# REQUEST FOR COUNCIL ACTION

AGENDA SECTION: PUBLIC HEARINGS –continued Item	ORIGINATING DEPT: PLANNING	ITEM NO. E-3
ITEM DESCRIPTION: General Development Plan #198, by Dave & Donna Geselle Trust and Lyndon Geselle Trust - Charles Geselle Trustee to be known as Villas on the Parkway. The applicant is proposing to develop a 4.8 acre parcel of land with uses permitted in the R-2 zoning district. The development would be served by public and private roadways. The property is located along the west side of West River Parkway NW, east of 4 <sup>th</sup> Avenue NW and south of 31 <sup>st</sup> St. NW.		PREPARED BY: Brent Svenby, Planner
<p>February 27, 2003      <u>NOTE:</u> Petition to oppose extension of 31st St. NW was not included in the packet.</p> <p><b>NOTE:</b> This item was continued at the previous meeting to allow the developer to redesign the proposed public roadway and its connection to West River Parkway. The roadway has been redesigned and now has a slight curve in it.</p> <p>Also the developer has stated that they would pay for the removal of the old 3<sup>rd</sup> Ave. NW roadway and subgrade and grade and re-seed the old right-of-way to provide a better drainage condit

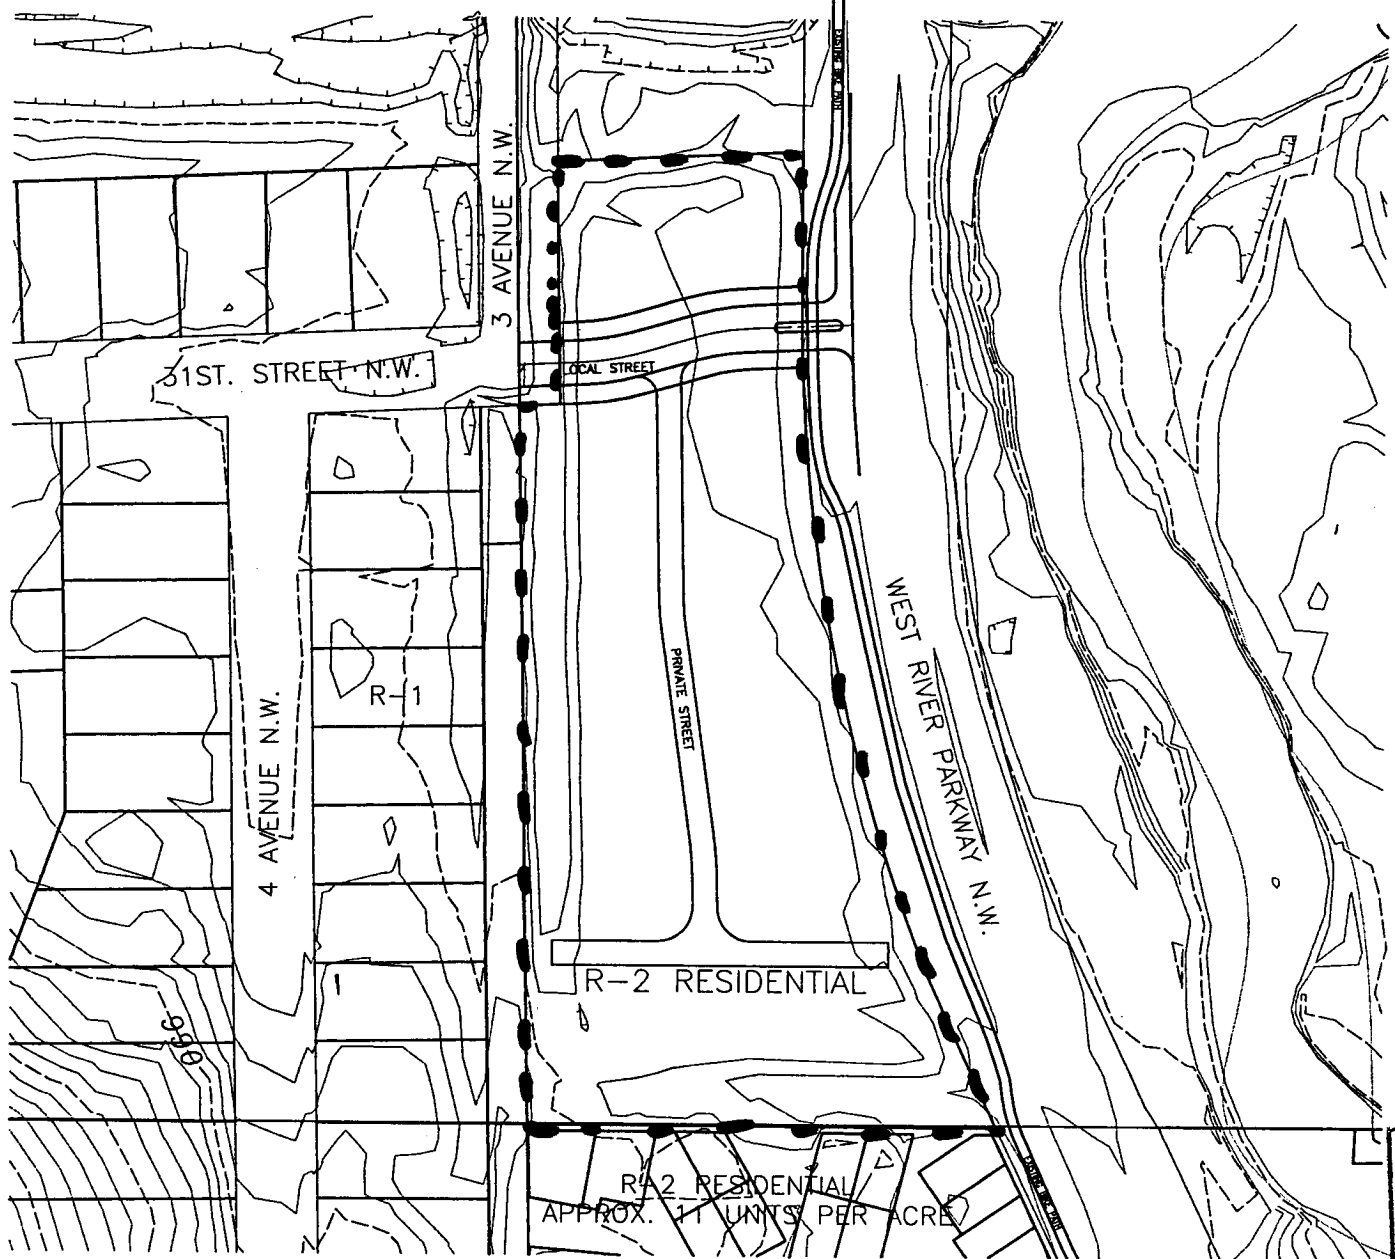
According to the GDP submitted the plan identifies a public street connection to West River Parkway. This would allow the continuation of 31<sup>st</sup> Street NW to West River Parkway. There would also be a private roadway extending southerly from the proposed public street. Turn lanes off of West River Parkway NW will need to be constructed on West River Parkway at the location of 31<sup>st</sup> Street NW. The owner will be obligated for their share of the cost of the reconstruction of 3<sup>rd</sup> Avenue abutting this property.

***This GDP proposes a low density residential development which is consistent with the land use designation for the property. The plan provides to the connection of 31<sup>st</sup> Street NW to West River Parkway NW. Also the portion of 3<sup>rd</sup> Avenue NW adjacent to this property will need to be reconstructed. The proposed density of the development is less than the density of the development located immediately to the south. A 5' wide sidewalk is required along both sides of the public roadways built as part of this development.***

***Access to this property will be from the proposed extension of 31<sup>st</sup> Street NW off of West River Parkway NW. The owner is responsible for the construction of turn lanes off of West River Parkway NW at the location of 31<sup>st</sup> Street NW to accommodate this development. Third Avenue NW will need to be reconstructed current with the development of the property. The owners are responsible for their proportional share of the cost of the reconstruction 3<sup>rd</sup> Avenue NW.***

2. At the time of platting, controlled access shall be dedicated along the entire frontage of West River Parkway and 3<sup>rd</sup> Avenue NW, with the exception of the proposed local street access (31<sup>st</sup> Street NW).

3. Storm water management must be provided for this development. A Storm Water Management fee will apply for the benefit of participation in the City's Storm Water Management Plan. During the construction of the development a temporary on-site detention facility will be required.

4. The owner is obligated to construct turn lanes off of West River Parkway NW at the location of the public street shown to West River Parkway NW. The owner is also responsible for the proportional share of the cost of the reconstruction of 3<sup>rd</sup> Avenue NW adjacent to the property.

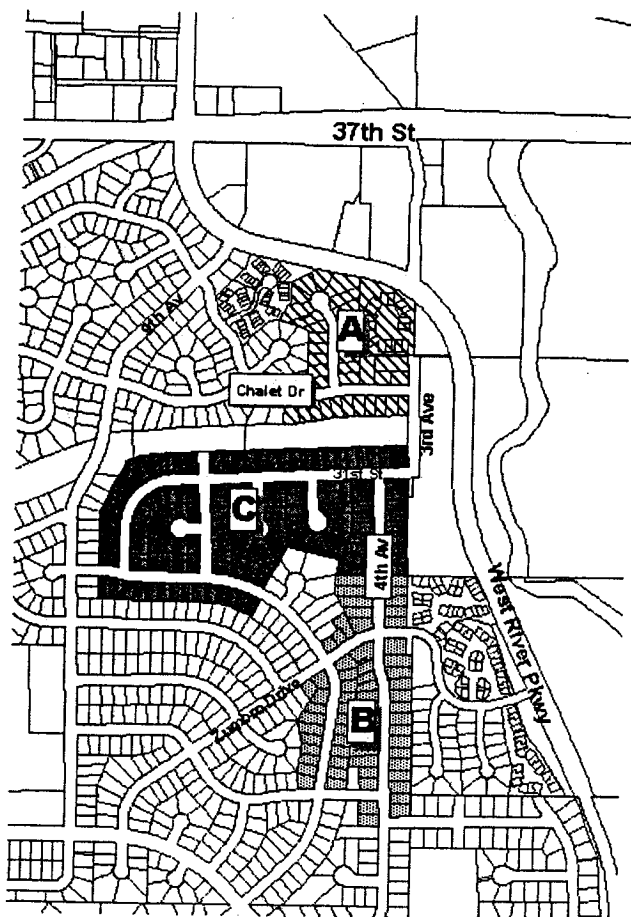
The concept of extending 31<sup>st</sup> St out to West River Parkway has raised concerns about the impact to traffic on 31<sup>st</sup> St. It would be my perspective there would certainly be a shift in the pattern of traffic in the immediate neighborhood (Area "C" on the illustration) that

wanted to travel north or south on West River Pkwy. This traffic would shift from traveling west or south out of Area "C" to 9<sup>th</sup> Ave or Zumbro Drive and would travel north or east to the 31<sup>st</sup> St access. Whether this is an appropriate course of action revolves around the question of whether this is "neighborhood" traffic and whether it is appropriate to reorient neighborhood traffic flows once they have been established.

In terms of existing non-neighborhood traffic, I expect the opening of 31<sup>st</sup> St would likely reduce or eliminate traffic on 4<sup>th</sup> Ave that comes from Area "A" (Chalet Drive) which travels down to Zumbro Drive to access West River Parkway for travel south towards downtown. Conversely, this reduction would likely be offset by an addition of traffic from areas south on 4<sup>th</sup> Avenue (Area "B") which would likely use a 31<sup>st</sup> St connection to travel north on West River Pkwy.

Since 31<sup>st</sup> St does not extend east of West River Parkway, it is my perspective there would be a very limited amount of other through traffic that would find 31<sup>st</sup> St as an attractive route. Looking at possible origins/destinations and travel route options off of West River Parkway (9<sup>th</sup> Ave, Zumbro Drive and 31<sup>st</sup> St if connected), it appears the most likely source of through traffic would be between the 3<sup>rd</sup> Ave / Hy-Vee shopping area and areas southwest of Area "B" directly along Zumbro Drive.

MEMO FROM CHARLIE REITER  
TRANSPORTATION DIVISION

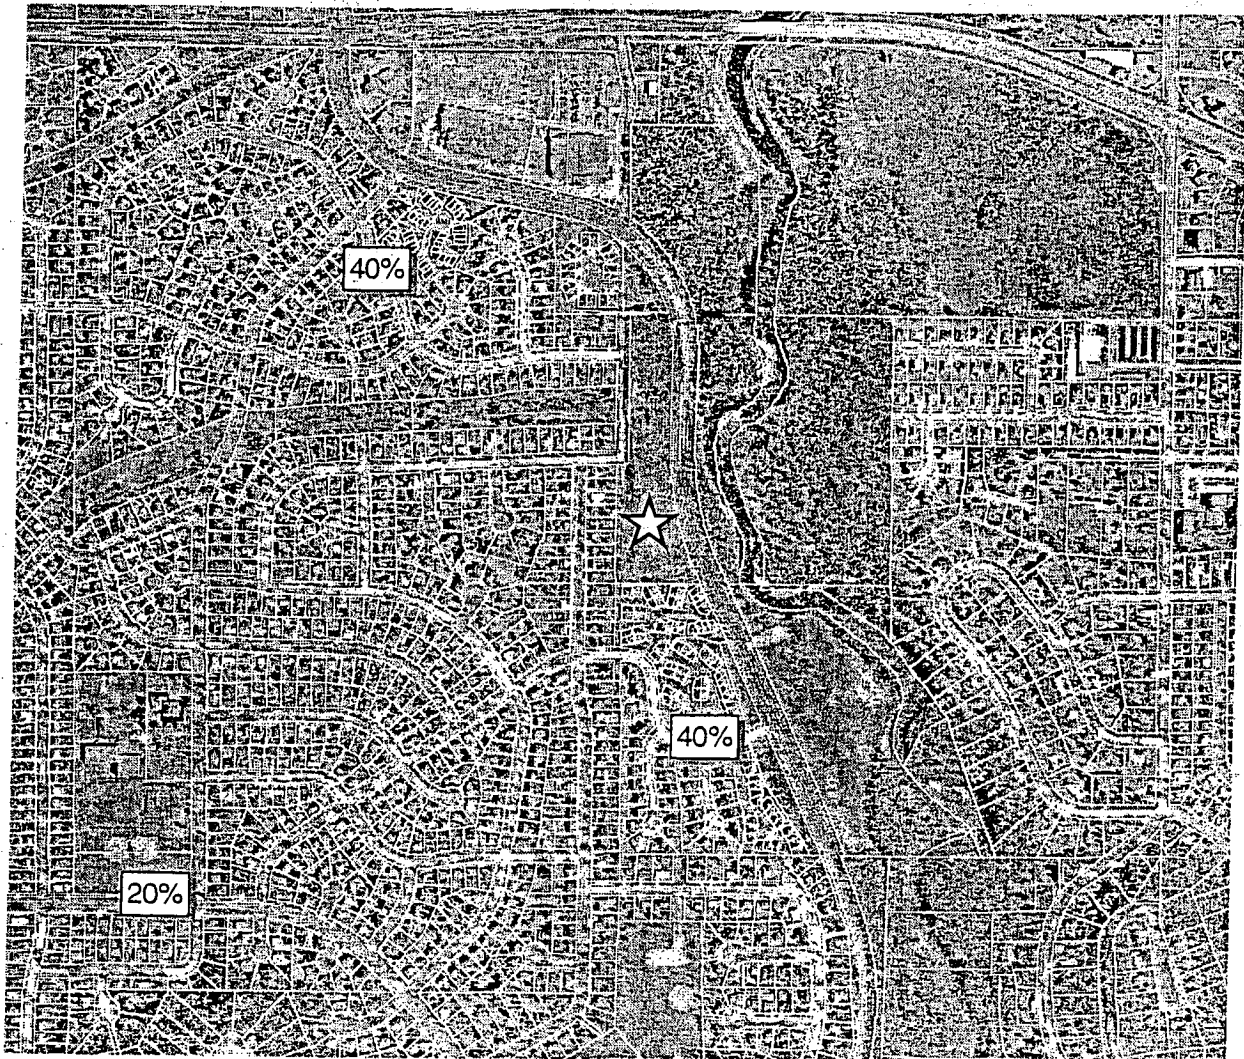
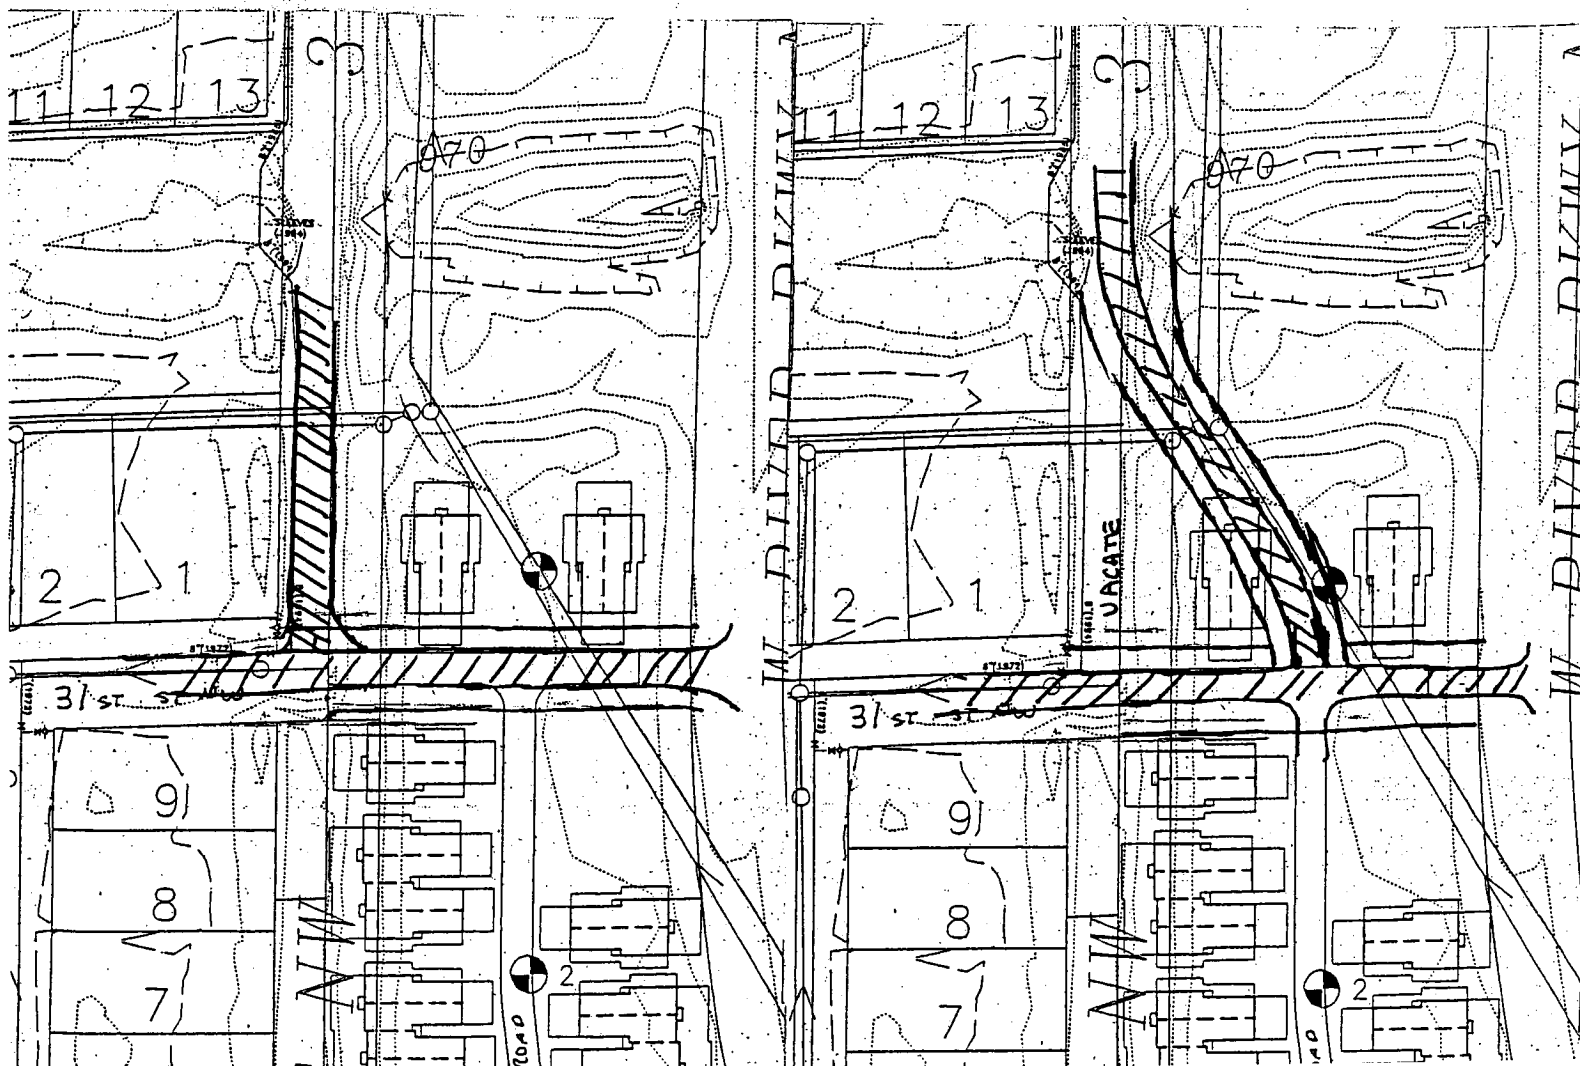
Street Design Issue - Should 31<sup>st</sup> St be extended to West River parkway?

- Would remove almost all of development traffic from neighborhood
- Spacing of intersection on West River Parkway is in good location - meets desired spacing (from Zumbro Dr to south and 3<sup>rd</sup> Ave to north) and appears to have good sight distance
- Would probably pull some traffic off of Zumbro Drive and maybe a small amount off of Chalet Drive/9<sup>th</sup> Ave (primarily traffic from 31<sup>st</sup> St area)

- Would add traffic to eastern end of existing 31<sup>st</sup> St
- Would pull traffic from Chalet Drive area desiring to go south on Parkway into the area
- Probably would result in the loss of some units in the development
